United States Patent and Trademark Office

APPLICATION NO.	FILING DATE	FIRST NAMED INVENTOR	ATTORNEY DOCKET NO.	CONFIRMATION NO.
10/709,637	05/19/2004	Ting-Jui Chang	11121-US-PA	3636
31561	7590 01/13/2006		EXAMINER	
JIANQ CHYUN INTELLECTUAL PROPERTY OFFICE			CHIEN, LUCY P	
7 FLOOR-1, NO. 100 ROOSEVELT ROAD, SECTION 2			ADTIBUT	DA DED MUMBED
			ART UNIT	PAPER NUMBER
TAIPEI, 100			2871	
TAIWAN			DATE MAILED: 01/13/2006

DETAILED ACTION

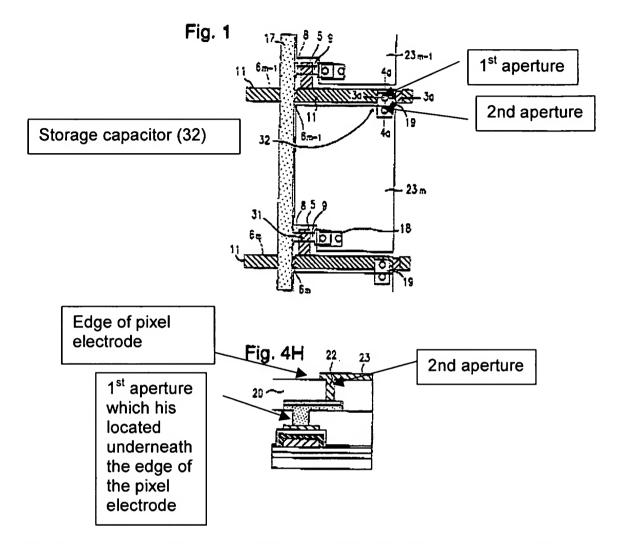
Applicant argues "a storage capacitor connection electrode 19" is not a storage capacitor. Examiner mislabled by mistake, Sakamoto, Fig. 1 discloses that the storage capacitor is labeled as (32). Therefore, Sakamoto Fig. 1 discloses wherein each storage capacitor (32) has an upper electrode (11) having at least a first aperture (shown below).

Regarding Claim 8, applicant argues that Sakamoto shows only one aperture in the form oe f a contact hole 2 located underneath the pixel electrode 23 without an aperture through the connection electrode 10. Shown above in the figures, Sakamoto shows one aperture located underneath the 2nd aperture. Sakamoto discloses (Column 9, Row 55-60) that labeled as 1st aperture shown above in Fig. 4H is first aperture) and 2nd is another aperture.
